**STAGE 1 DEVELOPMENT APPLICATION
PLANNING ASSESSMENT REPORT**

130-134 ELIZABETH STREET, SYDNEY

DEVELOPMENT APPLICATION: 130-134 ELIZABETH STREET SYDNEY**FILE NO:** D/2014/58**DEVELOPMENT APPLICATION NO:** D/2014/58**SUMMARY**

Figure 14: Aerial view of amended building envelope, illustrating the chamfered edge on the southwestern corner

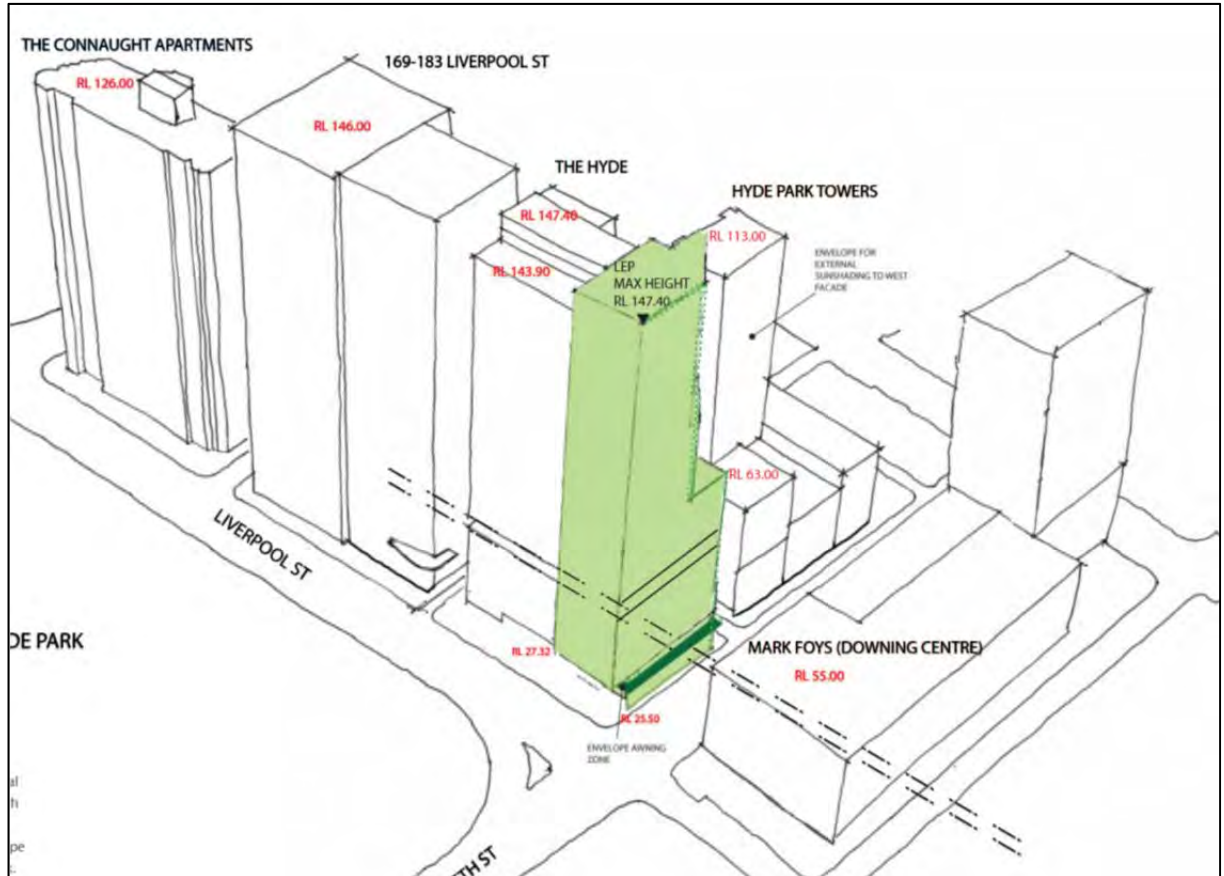
15. Amended plans and additional information were submitted on 14 May 2014 to address the above issues. The amended scheme has:
- (a) modified the building envelope to a more slender tower form for its upper levels, including a chamfered southwestern corner on Levels 14 to 36 of the proposal;

Figure 20: An axometric drawing of the originally lodged building envelope (to a height of 110 metres)

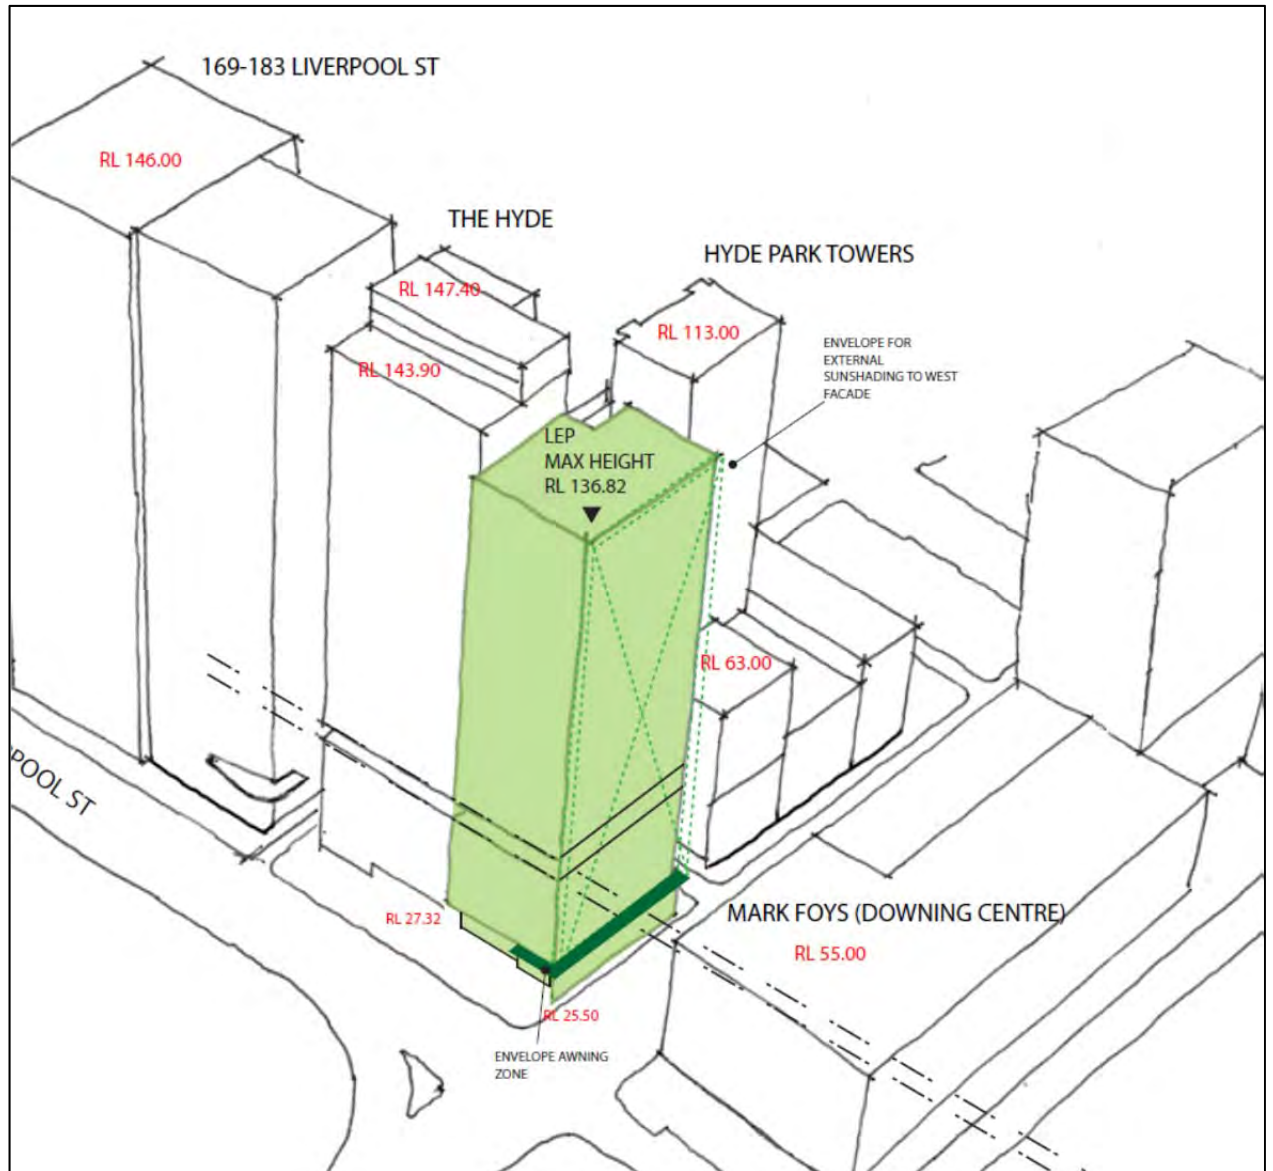
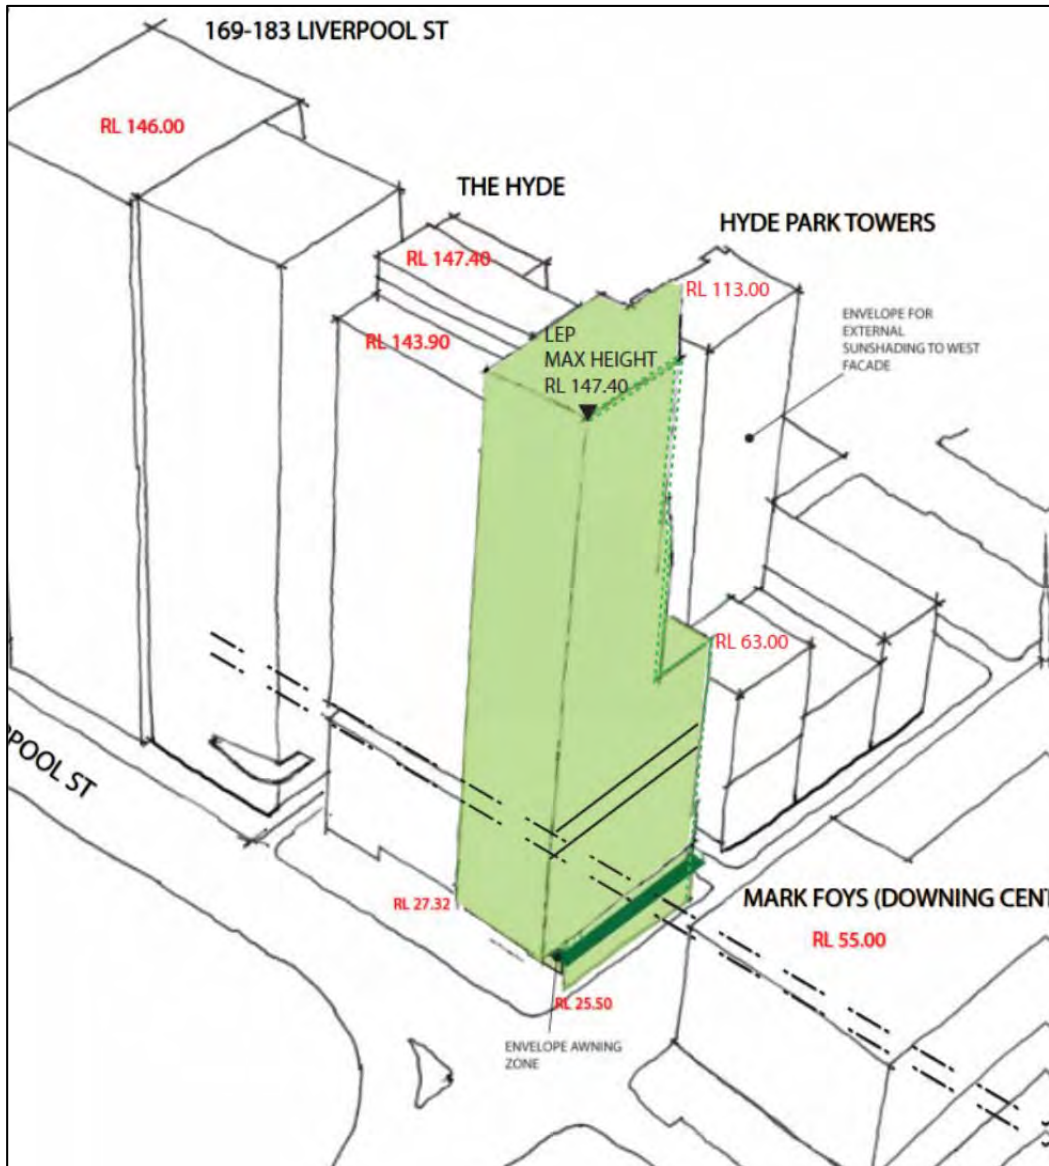
48. This amended scheme provides an alternative design response to the site by chamfering off the southwestern corner of the envelope on Levels 14 to 36 to create a more slender tower form. **Figures 18 to 21**, below, illustrates a comparison of floor plates and envelopes between the originally lodged scheme and the amended proposal.

49. In order to retain the yield of the originally envelope, the Applicant is seeking to increase the height of envelope by 10.5 metres to a maximum height of 120.5 metres (RL 147.40). **Figure 22**, below, illustrates the areas where the chamfered edge is proposed, and the additional height sought to the envelope to accommodate the redistributed floor space. This height would align with the top of the architectural roof feature of 'The Hyde' building located to the east of the site.

Figure 22: Proposed building envelope looking southwest, illustrating proposed chamfered corner and additional height where floor space is to be redistributed

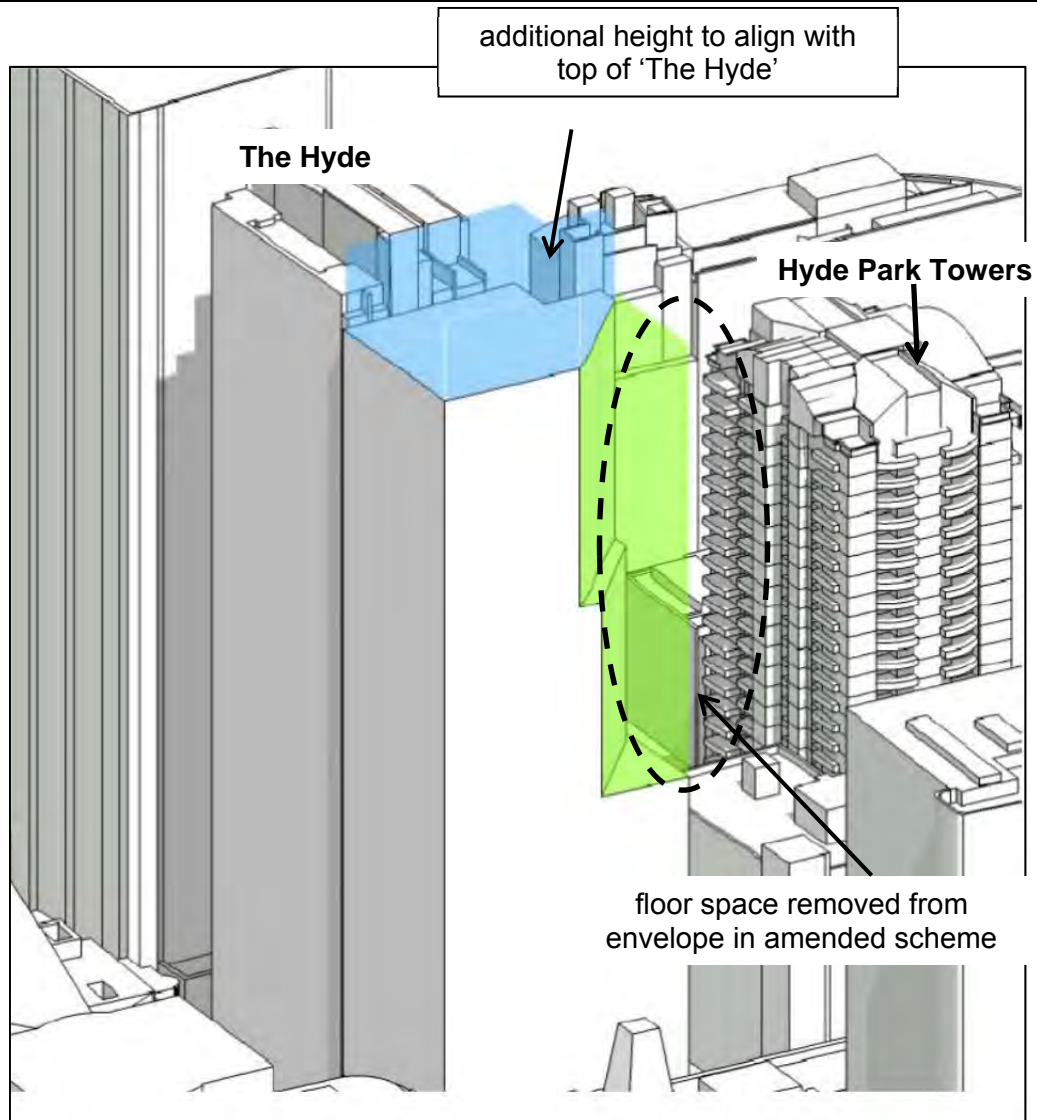
55. Clause 4.3 of the Sydney LEP 2012 stipulates a maximum building height of 110 metres for the site.
56. As originally lodged in January 2014, the proposal had a height of 110 metres. The revised scheme submitted on 14 May 2014 has sought to address the abovementioned solar access issue by redistributing floor space from the southwestern corner of the envelope (to the uppermost portion of the building (refer to **Figure 22**, above)).

Figure 23: View of the northern elevation of proposed building envelope illustrating the extent of technical breach to the building height development standard

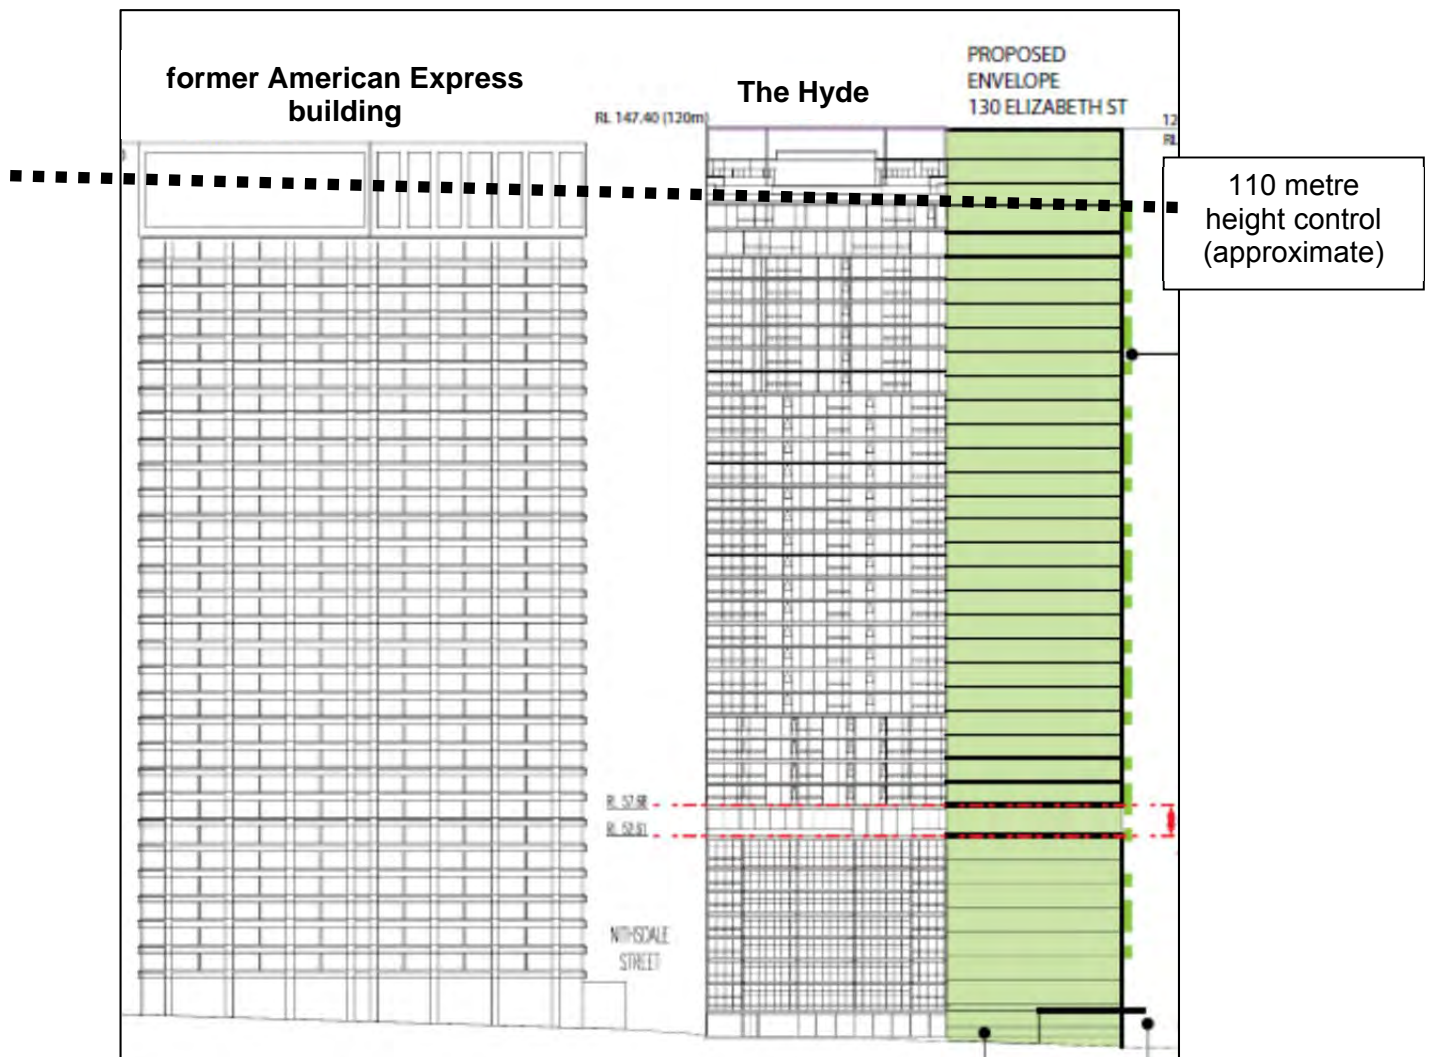
57. The amended proposal seeks to increase the maximum height of the building envelope to 120.5 metres. This results in a technical variation from the development standard by a maximum of 10.5 metres or a 9.5% variation. The applicant is relying on the provisions of Clause 4.6 of SLEP 2012 to vary the height development standard by a maximum of 10.5 metres.
58. **Figures 23 and 24**, below, illustrate those elements of the building envelope that are in breach of the building height development standard.

Figure 25: The proposed building envelope in its Liverpool Street context, noting that these buildings do not contain a street frontage height/podium

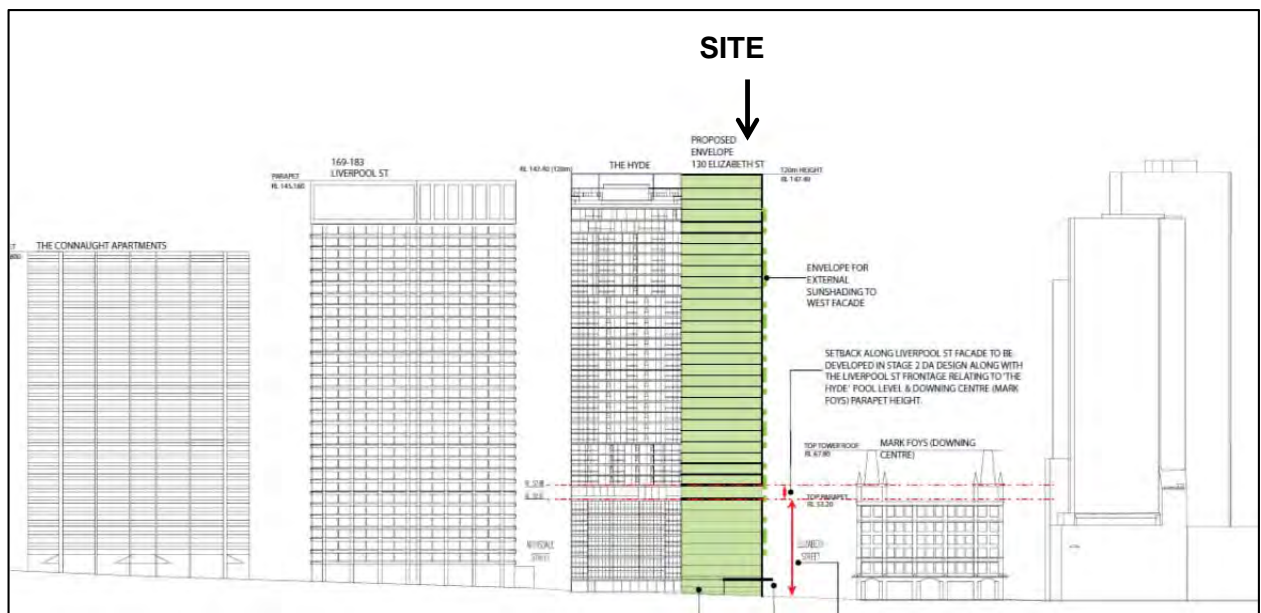
- (a) the proposed lack of a street frontage height on this site is contextually appropriate due to the established development pattern of buildings along Liverpool Street. The site's immediate neighbours to the east have been developed over a number of decades, and whilst all these sites have different street frontage widths and architectural styles, all have been developed with no podium and present a consistent setback pattern to the street. The continuation of this development pattern will provide definition to the public domain and strengthen the sense of enclosure to Hyde Park, which are desired elements for this Special Character Area as noted in SDCP 2012. **Figures 25 and 26**, below, demonstrate an analysis of this Liverpool Street context;
